LINCOLN PARK PLANNING COMMISSION

November 10, 2021 at 7 p.m.

Site Plan Review

Site Plan Review

4 WEST ELEVATION
 SCALE: 1/4" = 1'-0"

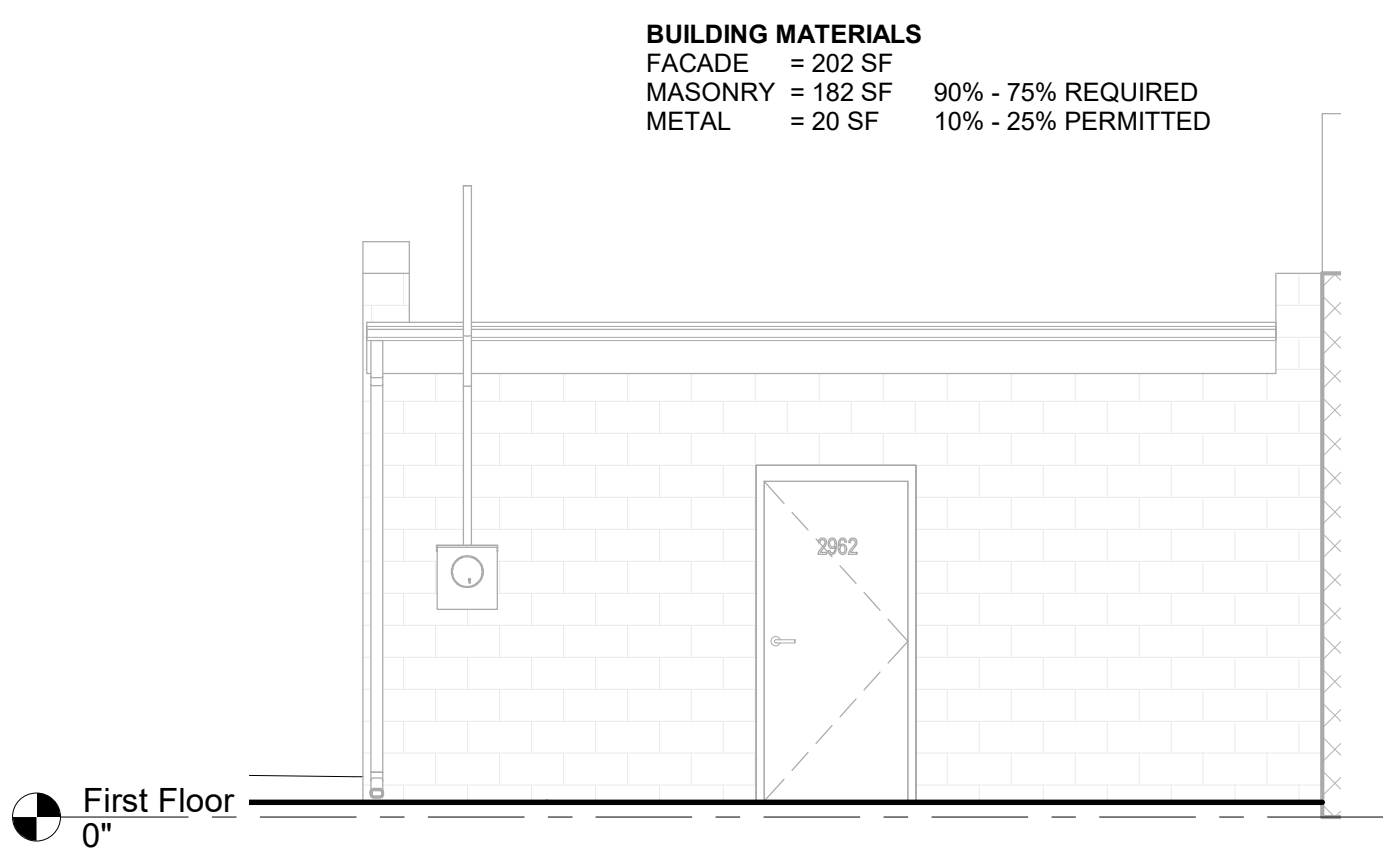
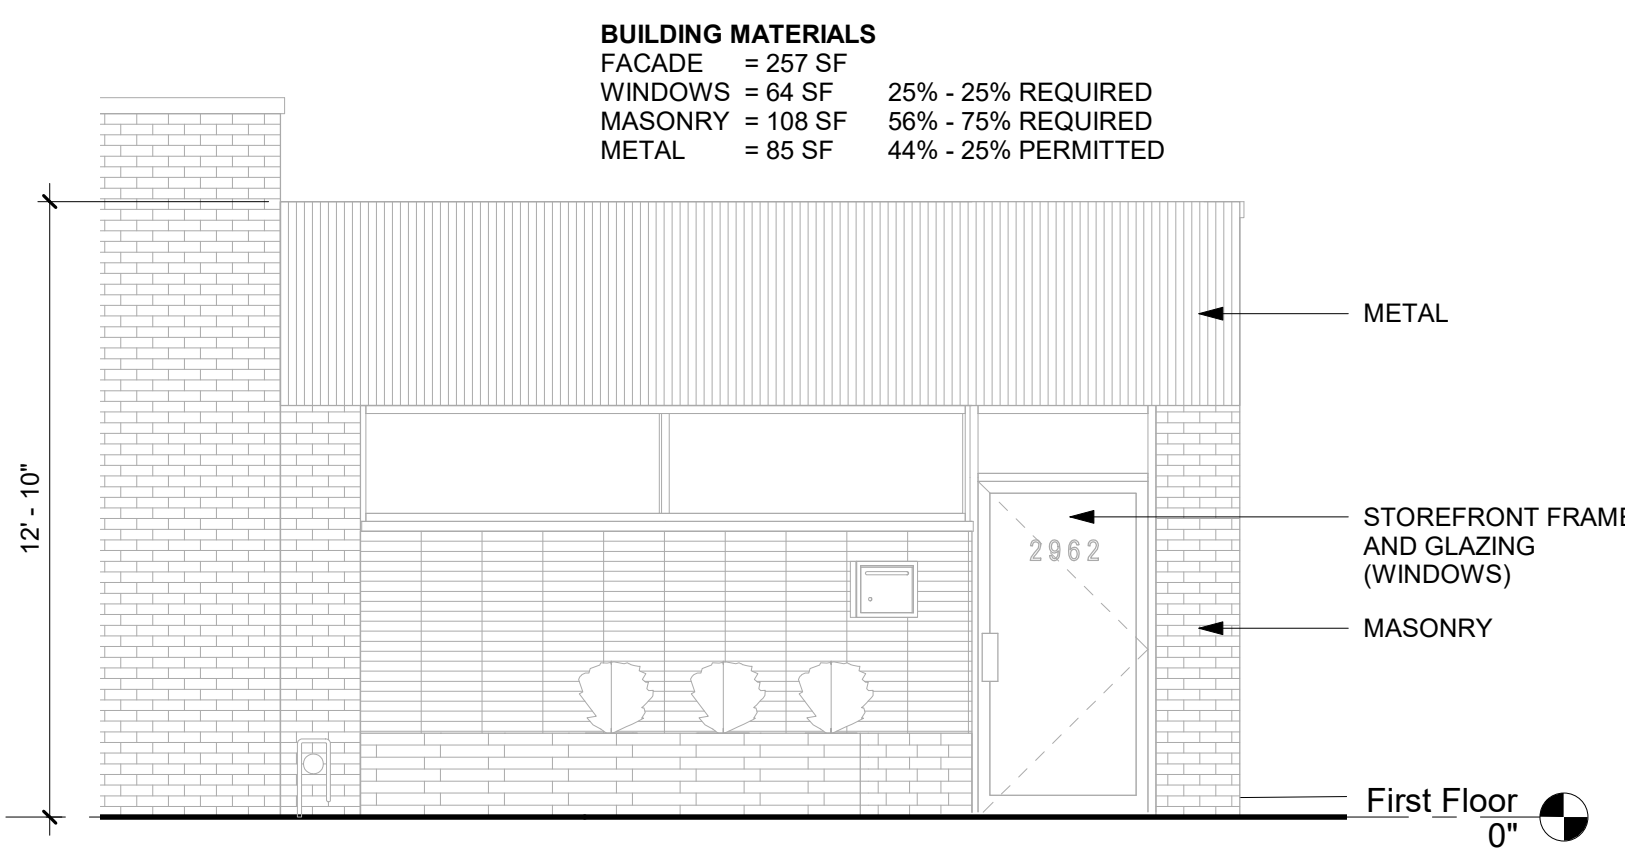
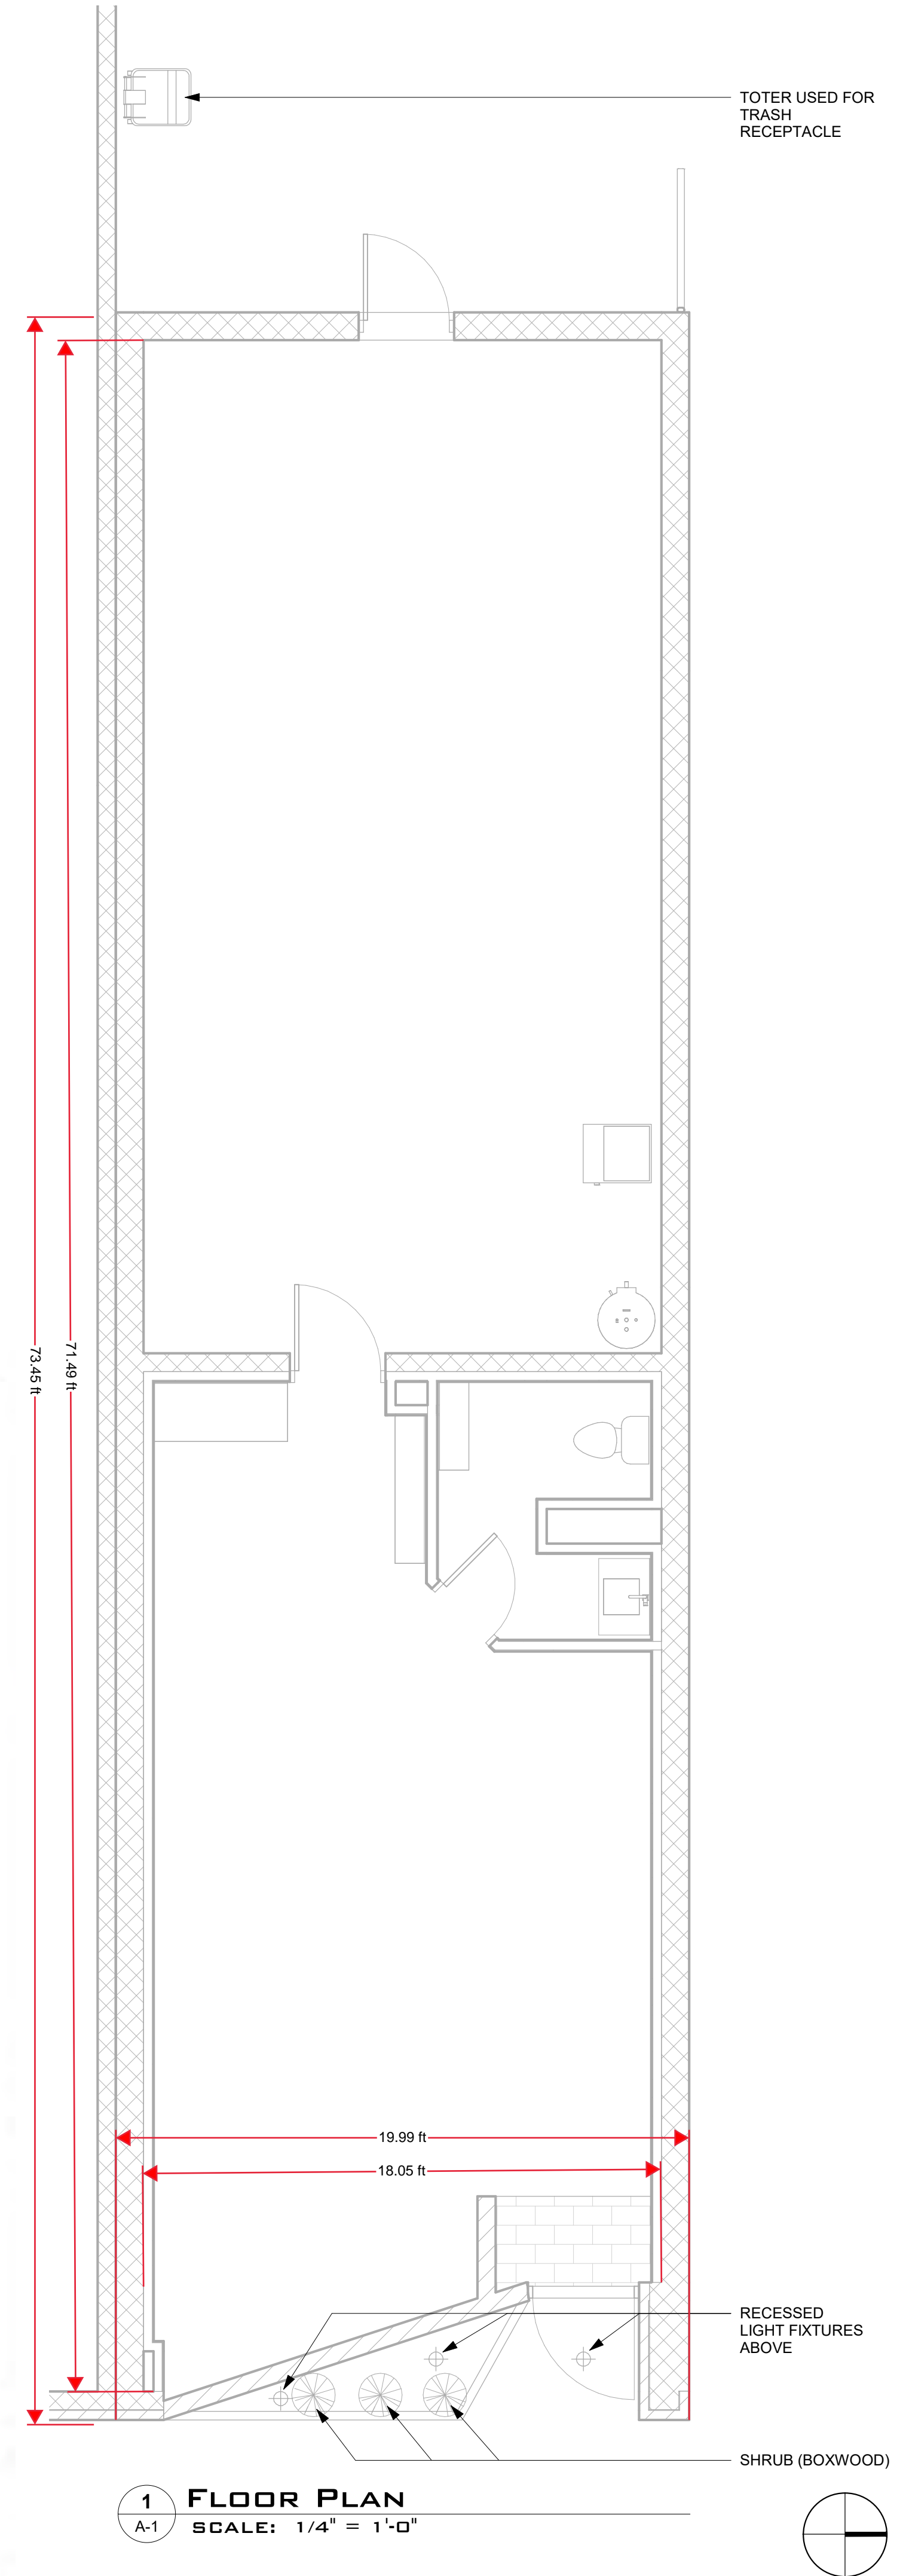
BUILDING MATERIALS
 FACADE = 257 SF
 WINDOWS = 64 SF 25% - 25% REQUIRED
 MASONRY = 108 SF 56% - 75% REQUIRED
 METAL = 85 SF 44% - 25% PERMITTED
